Access Compliance Report

Public Rights-of-Way

(Curb Ramps)

Intersection ID: 24925	Main Street: BIRNEN_DR	Cross Street: GLEN_LAUREL_WY	Location: NE
ADA ID: D90EDE5121EC	Ramp Type: PerpDiag	Initial Pass/Fail: Fail	Overall Compliance: No
		Severity Score: 12.5

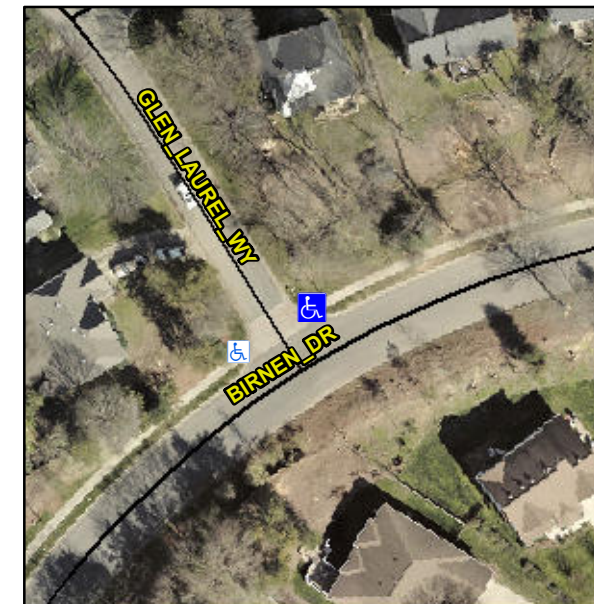
Not Found, R304.2.2

Compliance	Description	Data	Compliance	Description	Data
N/A	Ramp Length (in)	71.0	No	Ramp Slope (%)	9.1
Yes	Ramp Width (in)	49.0	Yes	Ramp XSlope (%)	1.1
N/A	Flare Type LT	N/A	N/A	Flare Type RT	N/A
N/A	Flare Slope LT (%)	N/A	N/A	Flare Slope RT (%)	N/A
N/A	Flare Traversable LT?	N/A	N/A	Flare Traversable RT?	N/A
N/A	Landing Length (in)	N/A	N/A	DWS Provided?	N/A
N/A	Landing Width (in)	N/A	N/A	DWS Contrast?	N/A
N/A	Landing Slope (%)	N/A	N/A	DWS Length (in)	N/A
N/A	Landing X Slope (%)	N/A	N/A	DWS Full Width?	N/A
N/A	Landing Curb? (Y/N)	N/A	N/A	DWS Offset (in)	N/A
N/A	Shared Landing?	N/A			
N/A	Gutter Ponding?	N/A	N/A	Gutter Slope (%)	N/A
N/A	Gutter Lip Ht (in)	N/A	N/A	Gutter X Slope (%)	N/A
N/A	Painted X Walk1?	No	N/A	Painted X Walk2?	No
	X Walk 1 Direction	To SW		X Walk 2 Direction	To S
N/A	X Walk 1 Width (in)	N/A	N/A	X Walk 2 Width (in)	N/A
	X Walk 1 Slope (%)	3.2		X Walk 2 Slope (%)	6.2
	X Walk 1 X Slope (%)	4.0		X Walk 2 X Slope (%)	4.0

Remove & Replace Curb Ramp With Two New Directional Ramps or Equivalent.
